31 March 2025

**DEVON MEADOWS/CASEY FIELDS SOUTH EMPLOYMENT PSP
SUBMISSION ON BEHALF OF RAILWAY PROPERTY DEVELOPMENTS PTY LTD
35 DEVON ROAD, DEVON MEADOWS (PSP PROPERTY: DM-27)**

PROPOSED UPDATED PLACE BASED PLAN
 35 DEVON ROAD, DEVON MEADOWS, Bunurong Country

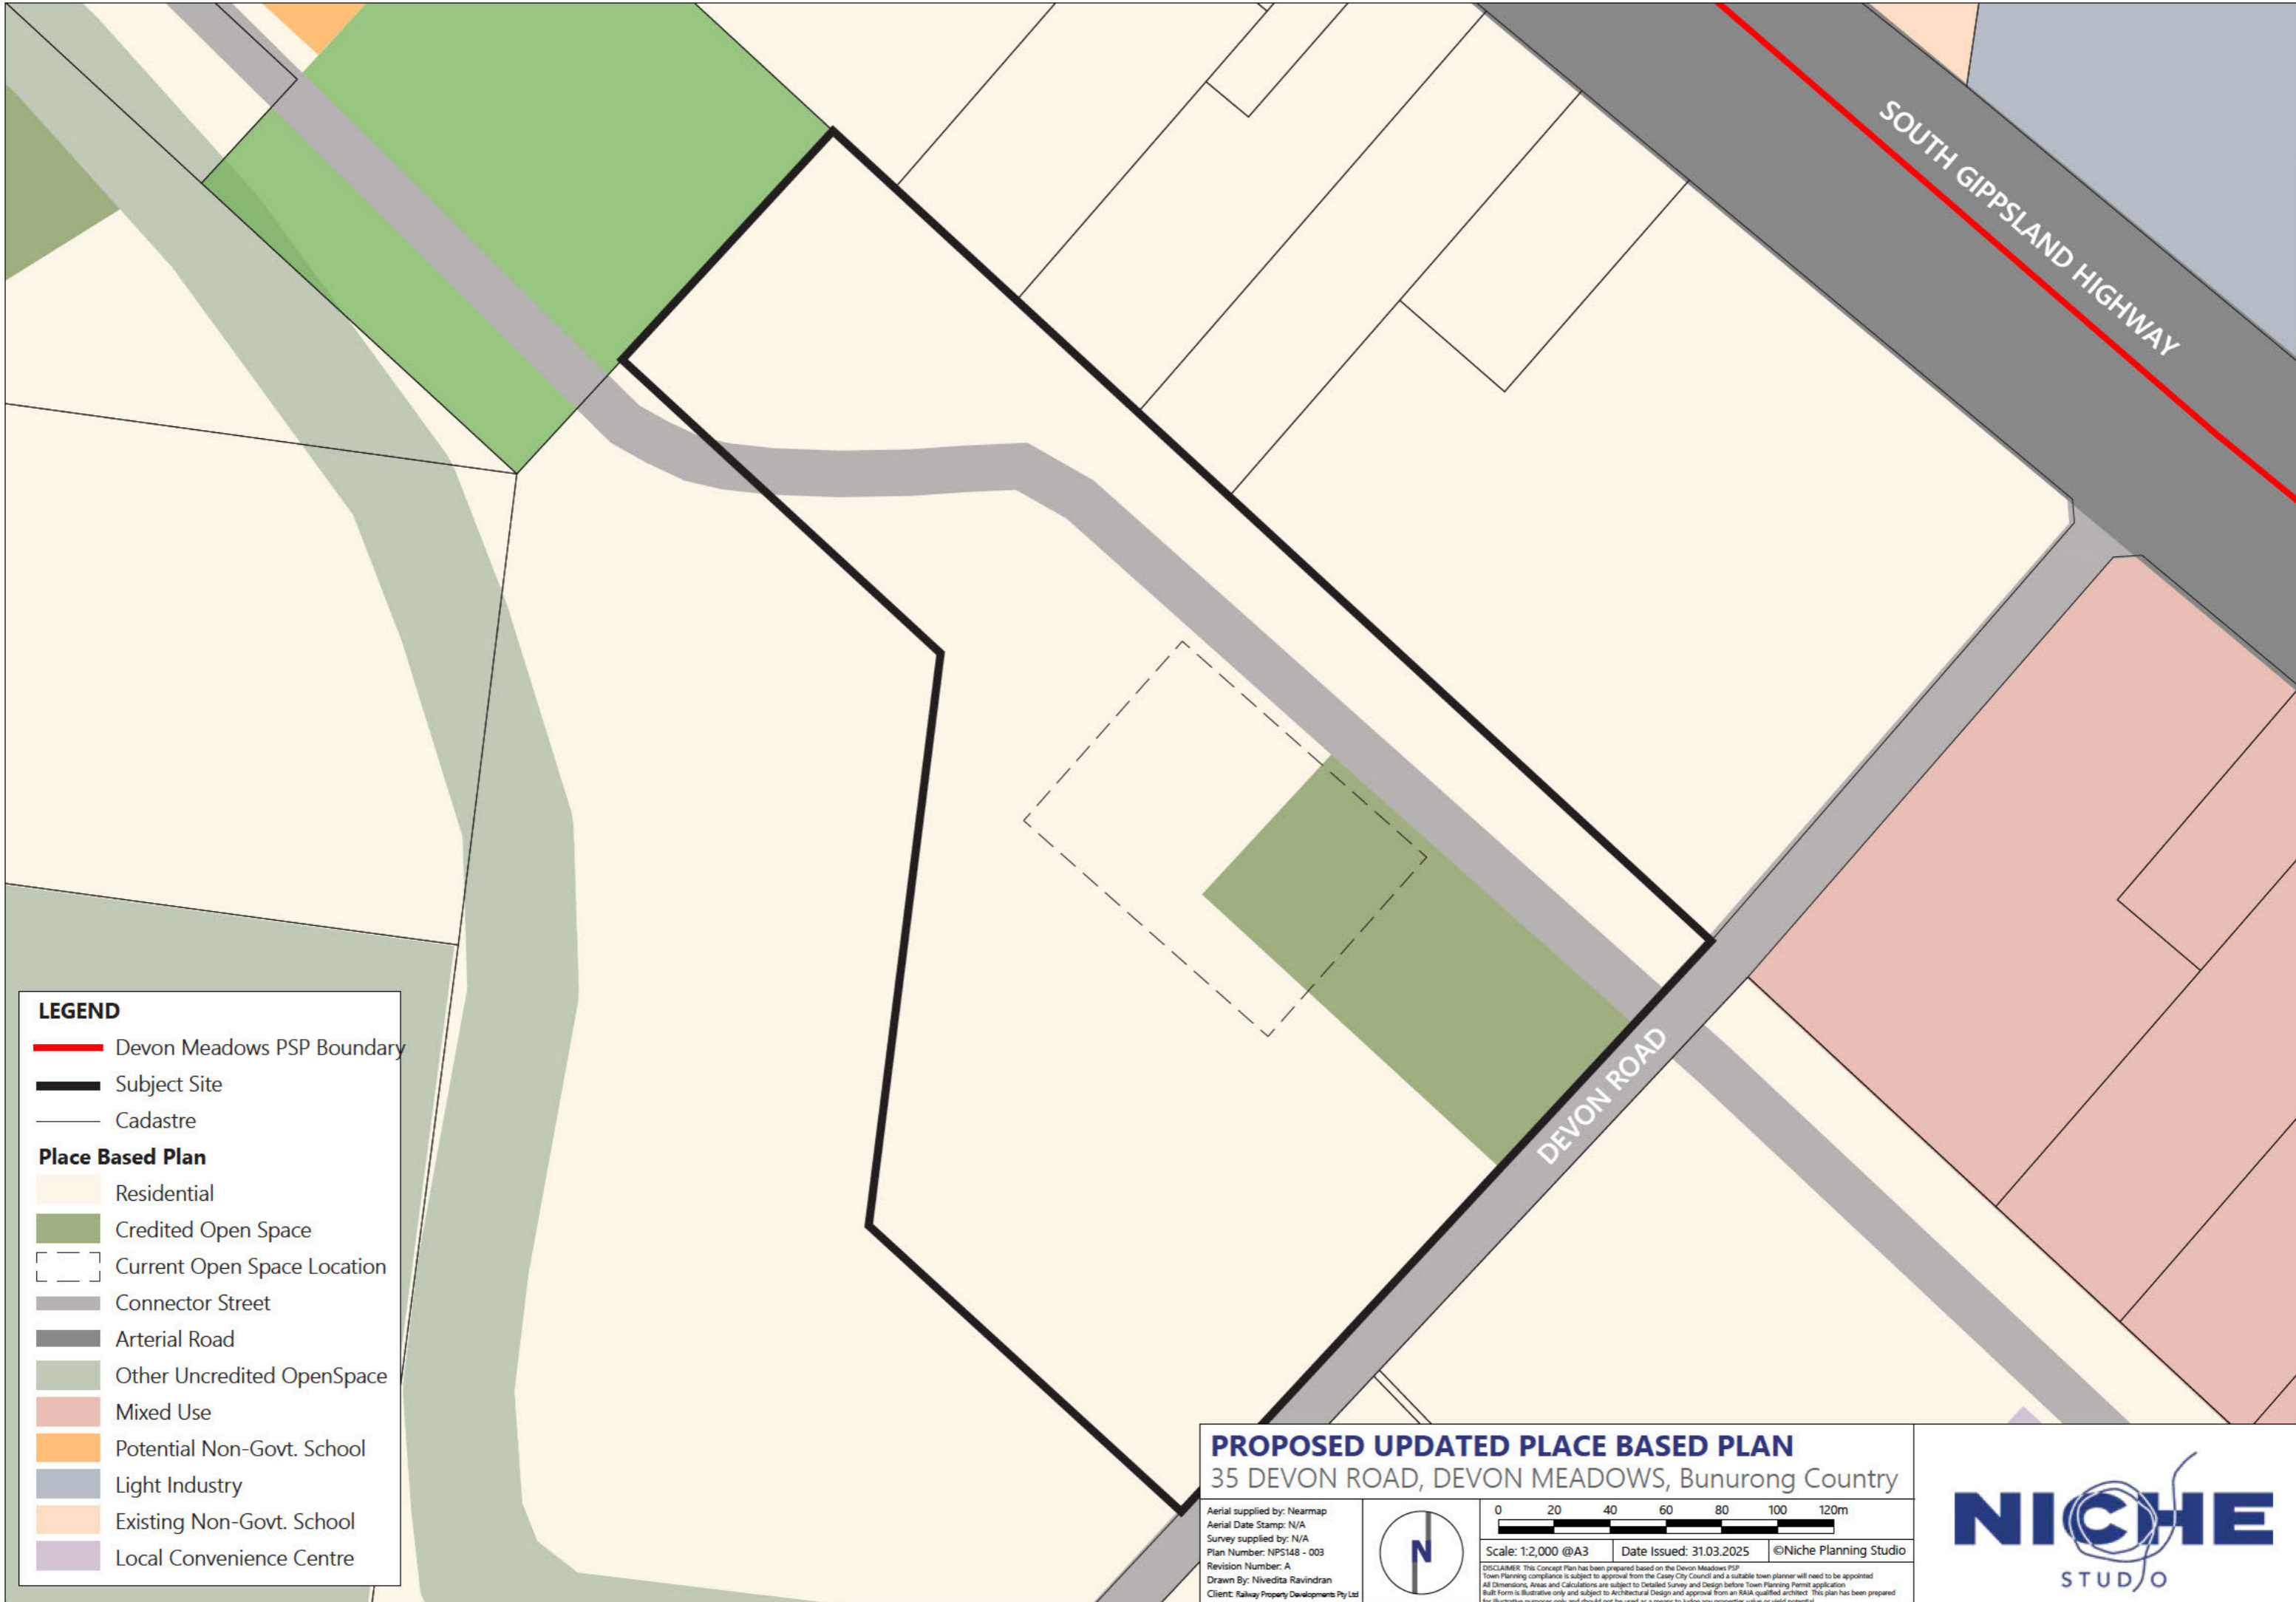
In reviewing the PSP, we support the designation of a 1ha Local Park (DM-LP-02) on the subject site, to allow for passive open space and amenity for future residents. However, we seek to relocate DM-LP-02 to the eastern boundary along Devon Road, to provide for an open space link close to the Mixed Use and Town Centre areas, as well as leveraging off the amenity of the existing native vegetation (discussed further in Item 2 below), which is required to be retained by Requirement 10 (R10) of the PSP.

This approach is consistent with recent PSPs, such as the Craigieburn West PSP & the Officer South PSP and would seek to consider a portion of the vegetated area as unencumbered open space (ie. as a local park), which would provide for the native vegetation to be retained and designed as part of a creditable open space. We also note that similar approaches have been undertaken in the Devon Meadows PSP, including DM-LP-01, DM-LP-04, DM-LP-05 & DM-LP-09.

We seek the same opportunity to retain vegetation within the local park afforded to DM-LP-02 to allow for the retention of some of the high-quality existing vegetation along Devon Road, incorporating this into the local park to allow for additional amenity opportunities.

- Relocate DM-LP-02 to the east along Devon Road, as per the attached plan (Attachment 1)
